Intel[®] Pentium[®] III Processor Specification Update

Release Date: December 2001

Order Number: 244453-036

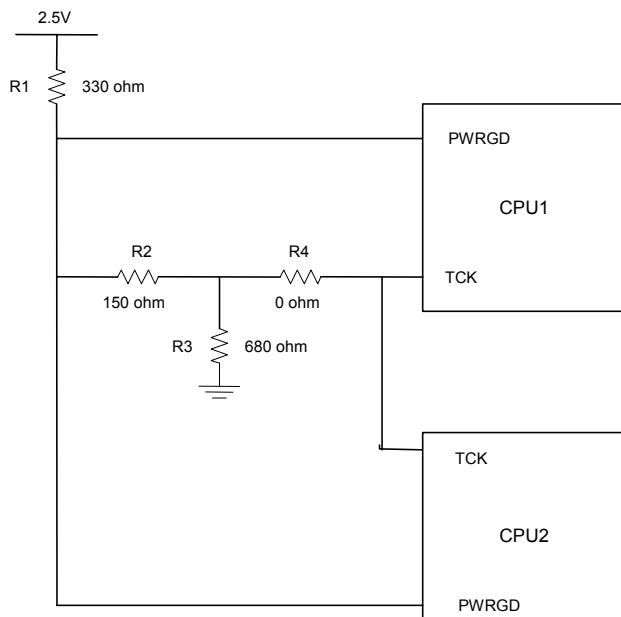
Problem: The internal control register bit responsible for operation of the Thermtrip circuit functionality may power up in a non-initialized state. As a result, THERMTRIP# may be incorrectly asserted during de-assertion of RESET# at nominal operating temperatures. When THERMTRIP# is asserted as a result of this erratum, the processor may shut down internally and stop execution but in few cases continue to execute.

Implication: This issue can lead to intermittent system power-on boot failures. The occurrence and repeatability of failures is system dependent, however all systems and processors are susceptible to failure. In addition, the processor may fail to stop execution during the event of a valid THERMTRIP# assertion resulting in the potential for permanent processor damage.

Workaround: To prevent the risk of power-on boot failures or catastrophic thermal failures, a platform workaround is required. The system must provide a rising edge on the TCK signal during the power-on sequence that meets all of the following requirements:

- Rising edge occurs after Vcc_core is valid and stable
- Rising edge occurs before or at the de-assertion of RESET#
- Rising edge occurs after all Vref input signals are at valid voltage levels
- TCK input meets the Vih min and max spec as mentioned in EMTS
